SUBJECT: Forwards response to 841219 telcon addressing Sandia recommendations for improvement in human factor engineering of BWR Owners Group graphic display sys. Discussion of signal validation logic also encl.

Subject: NUCLEAR PLANT NO. 2
GRAPHIC DISPLAY SYSTEM HUMAN FACTORS

ATTACHMENT A

Figure 1

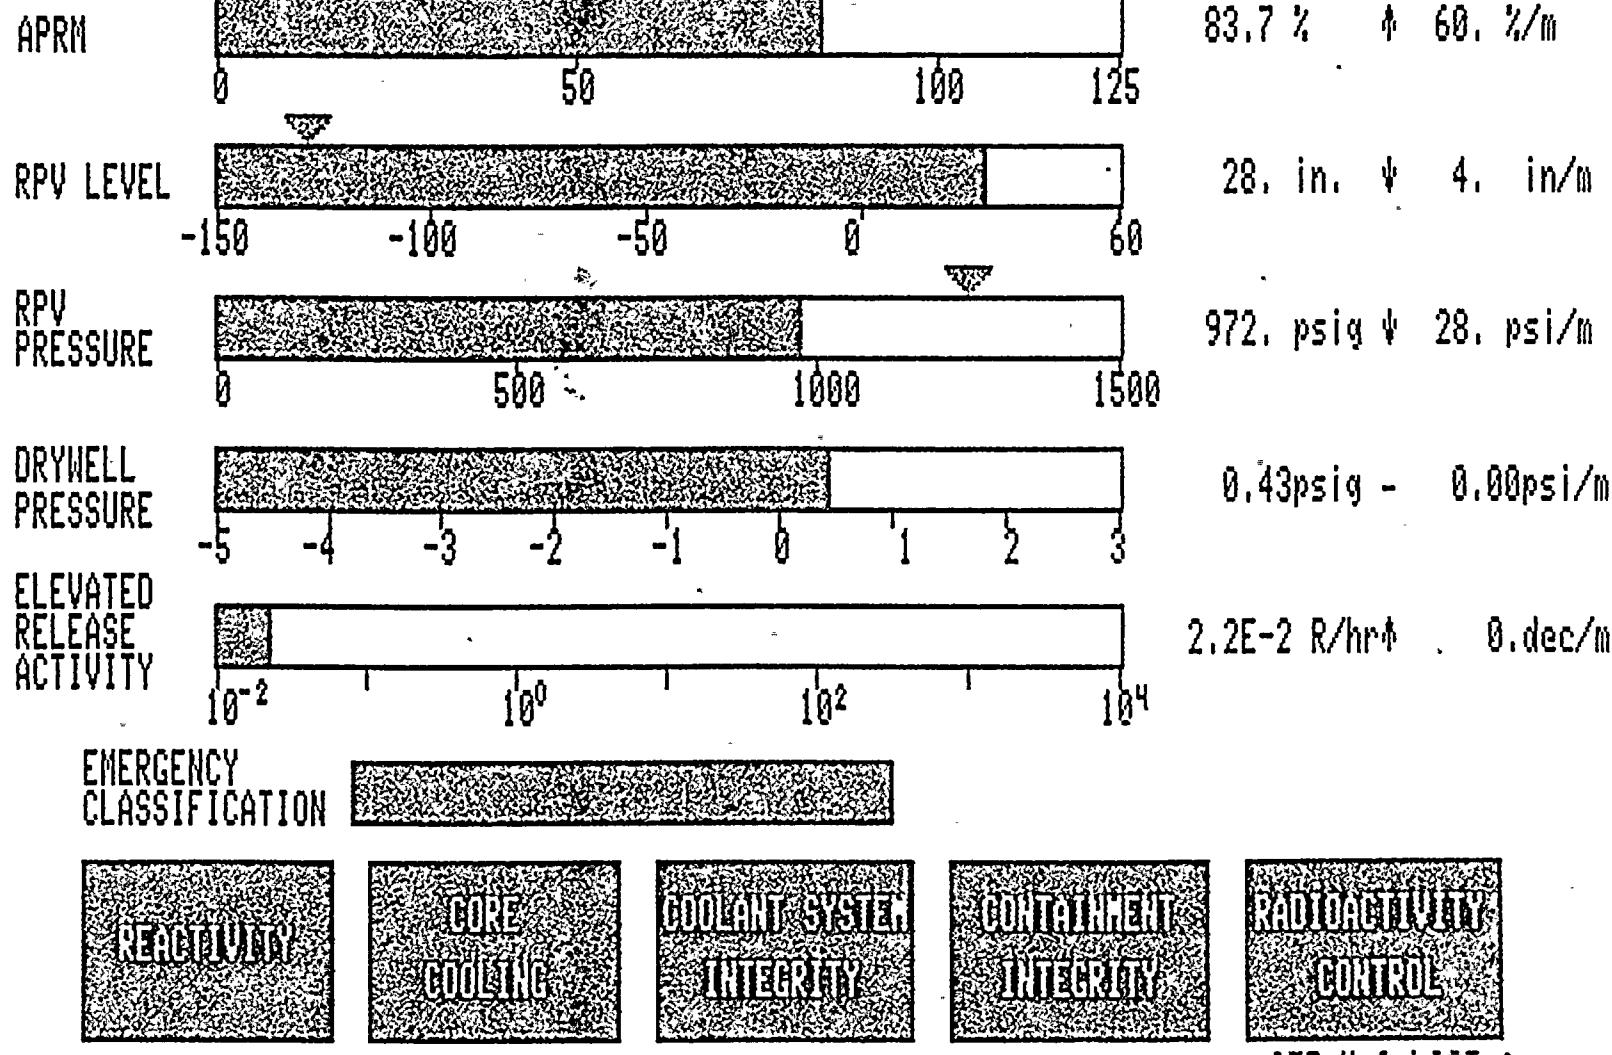
The bar displays presents a series of horizontal bars. Each bar represents a single parameter. The value of a parameter is determined from the length of the bar. In the GDS, all of the bars were oriented in the direction of the x axis.

The scales should be long enough that the operator can visually discriminate small but significant changes in direction of the bars. In the GDS, the length of the scale is limited by the dimensions of the CRT. In the practical sense, the most effective action option is to make the scale as long as the system will allow. Additional length can be obtained by:

- o reducing the size of the lettering and/or reformatting the labels on either side of the x axis of the bars, and
- o relocating the quantitative readouts above or below the associated bars. This modification might necessitate a reduction in the width of the bars in order to provide sufficient space.

Many of the critical tic marks were not labeled. Some of the operators expressed concern about this omission, particularly with regard to the absence of the alarm setpoint values. Labels should be provided for all critical tic marks.

The operators often commented that the tic marks were too small. The length of the tic marks should be increased. This may be accomplished by extending the tics into the body of the bar and/or by decreasing the width of the bars and extending the tics into the resulting space below the bar.

Operators commented on absence of color coding of the quantitative readouts. The use of color to indicate status would aid in the rapid comprehension of system status from the readouts.

The length of the bars on the WNP-2 displays were increased 23% and additional scaling values were added to improve the ability to discriminate changes in a parameter at a glance.

The labeling of tic marks was not incorporated due to the added clutter it creates. It was also assumed that a good operator knows what every alarm setpoint in the Technical Specifications is and, to date, our operators have never questioned what a tic mark represents.

The tic marks were completely redesigned to take the form of a triangle at the top of each bar. This increase in size has resolved this problem.

Color coding the numerical readouts for each parameter is a requirement of the design specification. That is to say, if the parameter exceeds a yellow or red alarm setpoint, the numerical readout of the parameter and the bar are supposed to change colors to yellow or red also. Due to software difficulties, the numerals do not change colors; however, the bars do. This is an outstanding issue at this time; however, as a result of upcoming computer changes, we expect to incorporate this improvement in the future along with a change to increase the size of the numerical readouts to the same height as the bar. We do not consider this a serious deficiency since there have never been any comments from our users regarding this issue.

Many of the specific comments regarding each bar display were also incorporated. In addition, several parameters used mostly for daily operations were added as an incentive to encourage daily use of the displays. An example of a bar display is provided in Figure 1.

Figure 2

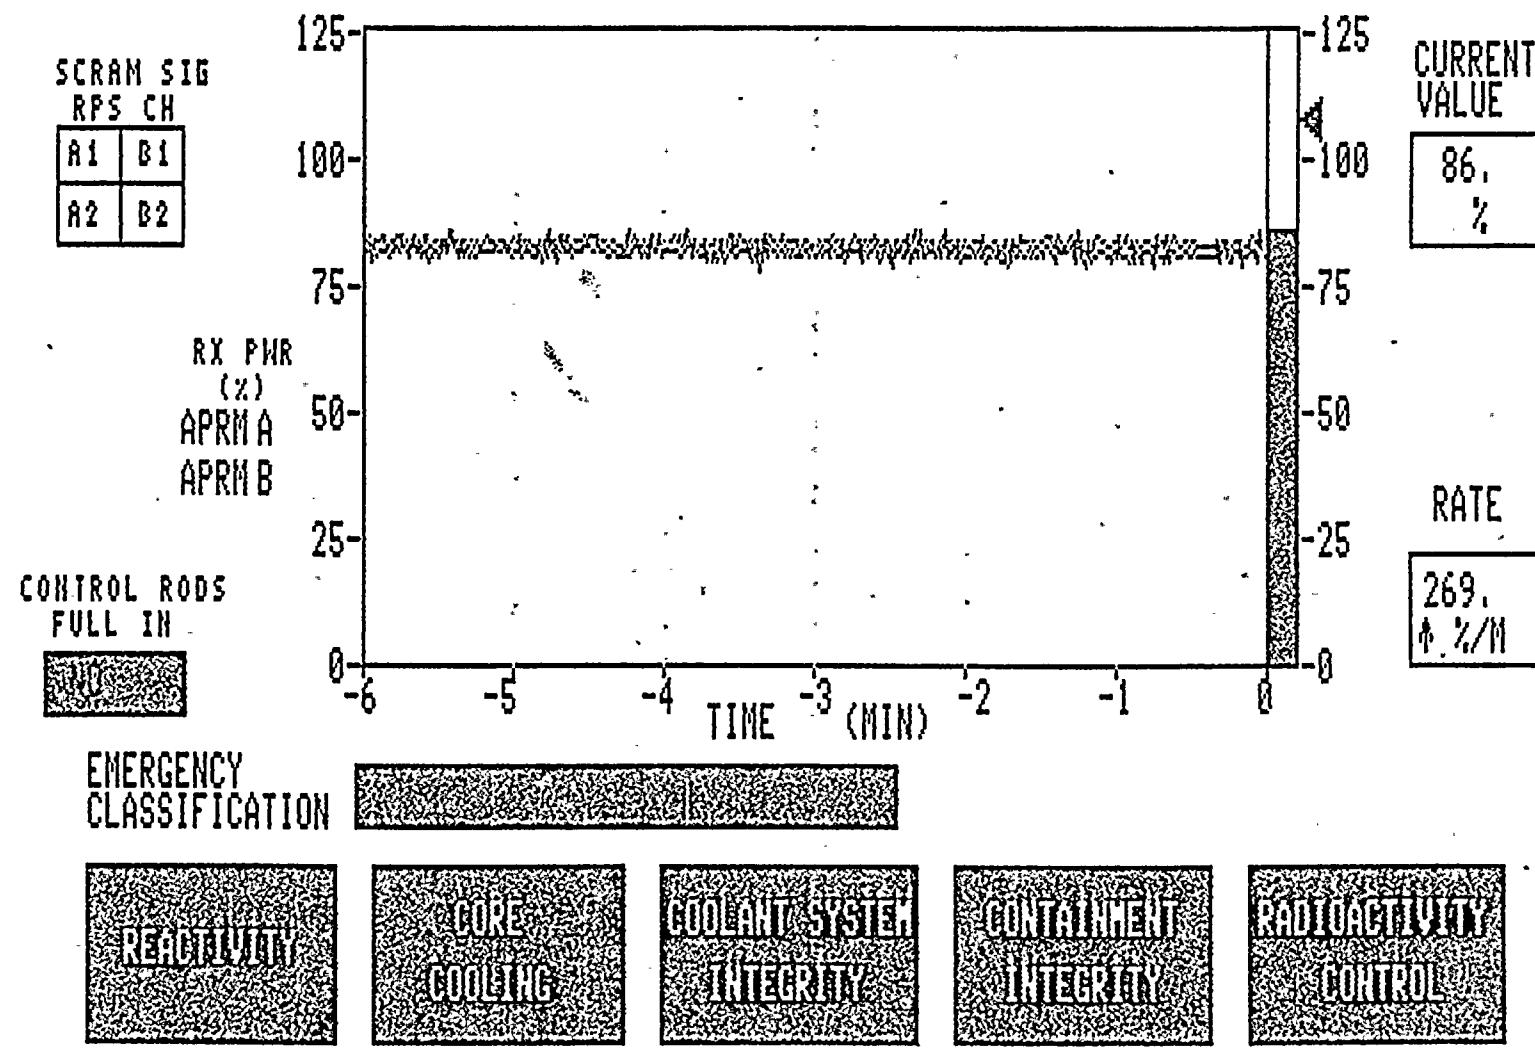
The primary usability problems reported by the operators was the difficulty in reading the display due to the limited length of the vertical scales, particularly on displays containing two or more graphs.

As in the case of the bar displays, the operators were concerned that the critical tic marks were not identified and the alarm setpoint values were not indicated. It was also noted that the units of measure of the readouts were not always identified. The displays should be redesigned to incorporate these features.

Operators commented on the absence of a y scale on the right side of the graph. The time history of the trend displays progresses from left to right with the most current value always on the right. No scale markings exist on the right side of the graph. The scale markings should be provided where they can be used by the operators, preferably on both vertical sides of the graph, or, if that is not feasible, on the right side of the graph. The tic marks should be made longer by extending them through the body of the graph as is done in the RPV Level (Fuel Zone)/RPV Pressure display.

The call-up time for the multiple displays ranged up to 14 seconds. A number of operators indicated that this was too slow. The reaction time of the system should be reduced.

The trend lines and readout boxes did not change color with a change of status. If both items made the same use of color as the bars in the bar displays, speed of detection of status changes would be aided.

In multiple graph displays, the operators reported difficulty in relating the readout boxes to the proper graphs. To aid operators in identifying the correct readings, the upper or lower border of the box could be eliminated and the box raised or lowered, as appropriate, to meet the border of the graph with which it is associated. Whatever the design solution, it should be employed consistently throughout all of the trend displays.

The problem of small scales was resolved on the WNP-2 GDS by displaying only one parameter trend at a time; plus having the option to display all trends for each safety group at the same time. In this way we have the best of both worlds. In addition, there are three colorgraphic CRT's in the operating zone of the control room. For each trend display, the trend area is maximized on the CRT to provide maximum clarity and detect small changes. Also, it has been found that the time scale for some parameters should be longer than six minutes and were changed accordingly. The reactor vessel mimic was deleted on all displays to make room for larger trends. Also, in an effort to bring the advantages of the bar display to the trend display, a vertical bar was added to each trend.

Tic mark labeling was not deemed significant and, in fact, causes problems with clutter. Refer to our response in the Bar Display section.

All our trend displays have scales on both sides of the trend. Tic marks have been improved by using larger color coded triangles.

Display call-up times for all singular displays varies from 7 to 14 seconds for the first time it is called up. After a display has been called up once and then is asked for a second time (i.e., after going to another display), it will be displayed in less than 2 seconds. Multiple trend displays take approximately 30 seconds to become active. These times are not much of an improvement over the original BWROG displays, but this is limited by the current technology, not our desire to improve it.

The WNP-2 GDS displays incorporated a vertical bar which changes color according to alarm points. This, along with the color change in the readout boxes, aids in the detection of status change changes.

This is a non-problem since all our trend displays are singular parameter displays.

In addition to the short term real time trends provided by the standard set of GDS displays, the STA console, TSC consoles, and EOF consoles all have the capability of calling up "GDS Historical" displays which consist of extended time scales of all GDS trends. There are 6 time scale options as follows: 1 hour, 8 hours, 24 hours, 48 hours, One week and Two weeks. A hard copy color printout capability is also being added in early 1985. Figures 1, 2, and 3 are examples of this capability. An example of trend displays is provided in Figure 2.

Figure.3

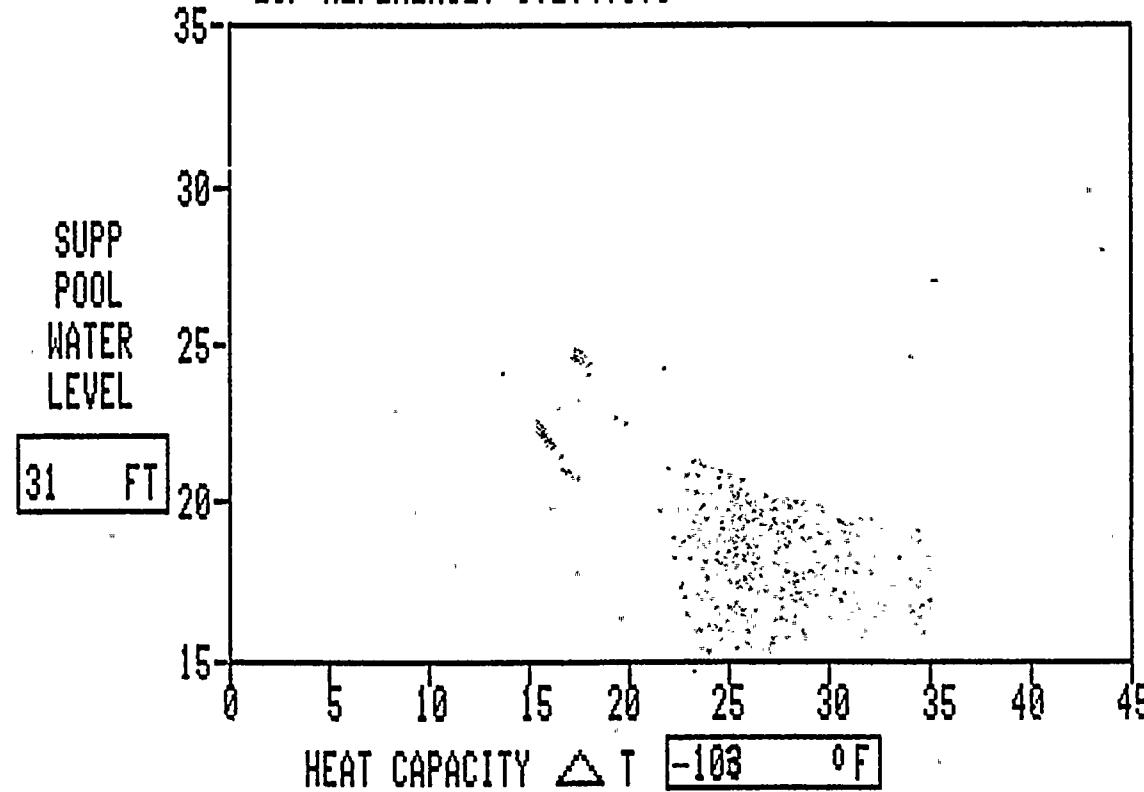
The position marker (x) presently used interferes with the operators' ability to read a value when it approaches the boundary of the graph or when the trend line moves in the same direction as one of the legs of the x. The x should be replaced with an open-centered x, or a circle, or a triangle so that it does not cover needed information.

The labeling of the x axis was typically located along side the upper horizontal boundary of the graph. The placement confused many of the operators because of the stereotyped expectation that this location is used for labeling the y axis.

The WNP-2 GDS uses an equal-armed rectilinear cross (+) with a red dot in the middle. When the cross moves, the red dot stays and leaves a trail of where it's been and provides insight into which direction it's trending. As it approaches the limit boundary and subsequently crosses it, there is no interference with the operators' ability to know the relationship between the center of the cross and the boundary line. This is primarily due to the red center of the blue cross.

The labeling of these displays is in the same location and similar format as all other displays and, thus, the confusion experienced on the BWROG displays was eliminated. In addition, all units are defined on the same axis as the scale, and all titles are in the upper left hand corner opposite the time.

To aid in the interface with the Emergency Operating Procedures, these displays provide a reference to the specific section of the Chapter 5 Emergency Operating Procedures (EOP) to which each display is used. Some displays have more than one reference.
